# CITY OF ALBUQUERQUE

**RE: Sawmill Village Phase 2  
Grading Plan  
Stamp Date: 7/24/17  
Hydrology File: H13D025A**

Based upon the information provided in your submittal received 7/24/17, the Grading Plan **is not** approved for Building Permit. The following comments need to be addressed for approval of the above referenced project:

DMG. 2426

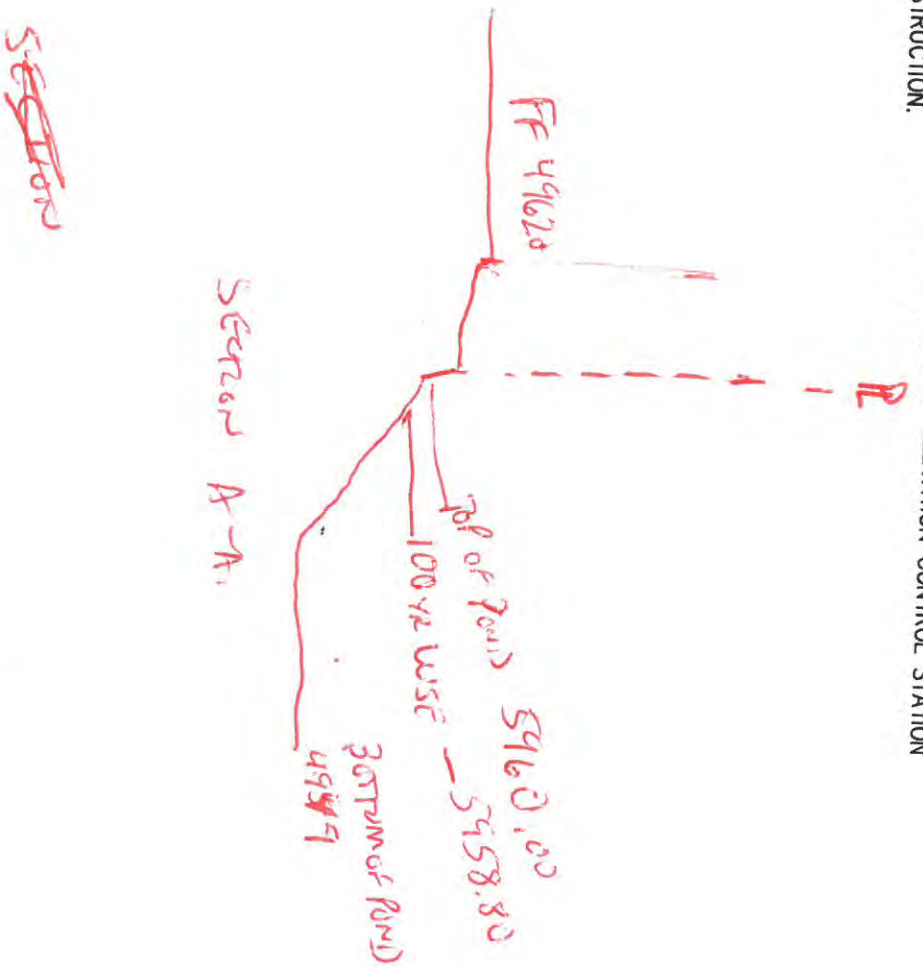
1. Please provide the required 0.87' water block per COA Paving Detail No. 2426.
2. Please provide the three point chart for each driveway radius per COA Paving Detail No. 2426.
3. Please provide a section through the proposed building and existing adjacent pond. Please label the elevations of the top of pond, the bottom of pond and the 100 year WSE.

I have attached the COA Paving Detail No. 2426 and the proposed section for your use.
